RI DEPARTMENT OF ENVIRONMENTAL MANAGEMENT
OFFICE OF WATER RESOURCES
FRESHWATER WETLANDS PROGRAM
APPROVED WITH CONDITIONS AS SPECIFIED IN THE LETTER OF APPROVAL
DATED: APR 19 2023 FILE #: 22-0509
NO CHANGES ALLOWED WITHOUT PRIOR APPROVAL
APPROVED PLANS MUST BE AT CONSTRUCTION SITE

SITE PLAN section containing Assessor's Plat 191 Lot 51, 136 Lake Shore Drive, Burrillville, RI. Prepared for: Nicholas Barone, 1035 Jackson Schoolhouse Road, Pascoag, RI 02859. Job # 22-049, Scale 1 inch = 10 feet, Drawn by LMB, Date December 2022. Includes professional seal for Paul D. Carlson, Registered Professional Engineer Civil, No. 7142. Also includes InSite Engineering Services, LLC logo and contact information.

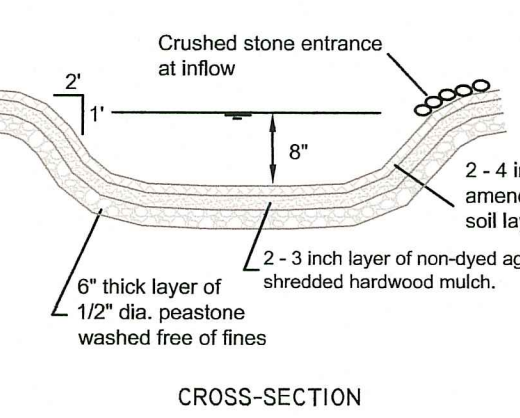
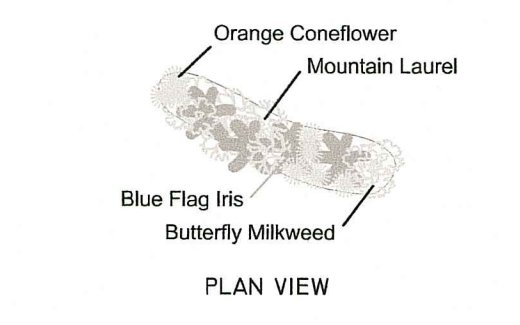
Dock not approved under this permit - see condition #13 in permit letter
